Access Compliance Report

Public Rights-of-Way

Intersection ID: 10193	Main Street: N_GRAHAM_ST	Cross Street: WOLFBERRY_ST	Location: S
ADA ID: B1B1C88037ED	Ramp Type: Perp	Initial Pass/Fail: Fail	Overall Compliance: No
		Severity Score: 12.5

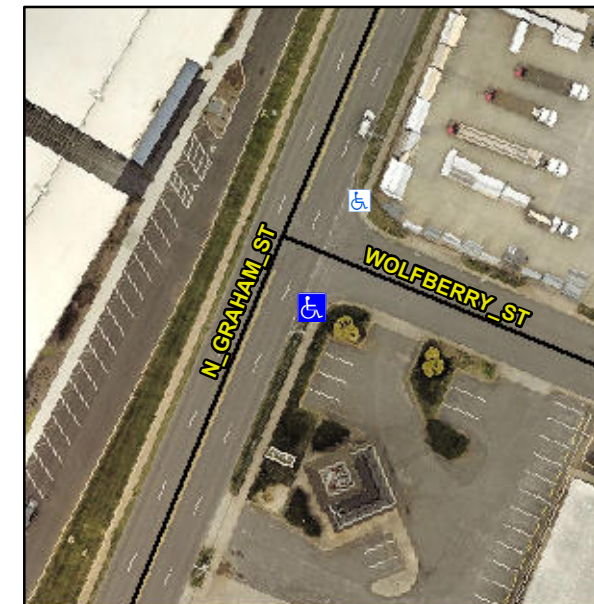
Not Found, R304.2.2

Compliance	Description	Data	Compliance	Description	Data
N/A	Ramp Length (in)	75.0	No	Ramp Slope (%)	10.5
Yes	Ramp Width (in)	61.0	Yes	Ramp XSlope (%)	1.4
N/A	Flare Type LT	N/A	N/A	Flare Type RT	N/A
N/A	Flare Slope LT (%)	N/A	N/A	Flare Slope RT (%)	N/A
N/A	Flare Traversable LT?	N/A	N/A	Flare Traversable RT?	N/A
N/A	Landing Length (in)	N/A	N/A	DWS Provided?	N/A
N/A	Landing Width (in)	N/A	N/A	DWS Contrast?	N/A
N/A	Landing Slope (%)	N/A	N/A	DWS Length (in)	N/A
N/A	Landing X Slope (%)	N/A	N/A	DWS Full Width?	N/A
N/A	Landing Curb? (Y/N)	N/A	N/A	DWS Offset (in)	N/A
N/A	Shared Landing?	N/A			
N/A	Gutter Ponding?	N/A	N/A	Gutter Slope (%)	N/A
N/A	Gutter Lip Ht (in)	1.0	N/A	Gutter X Slope (%)	N/A
N/A	Painted X Walk1?	No	N/A	Painted X Walk2?	N/A
	X Walk 1 Direction	To NE		X Walk 2 Direction	N/A
N/A	X Walk 1 Width (in)	N/A	N/A	X Walk 2 Width (in)	N/A
	X Walk 1 Slope (%)	0.4		X Walk 2 Slope (%)	N/A
	X Walk 1 X Slope (%)	0.7		X Walk 2 X Slope (%)	N/A

Remove & Replace Entire Ramp.
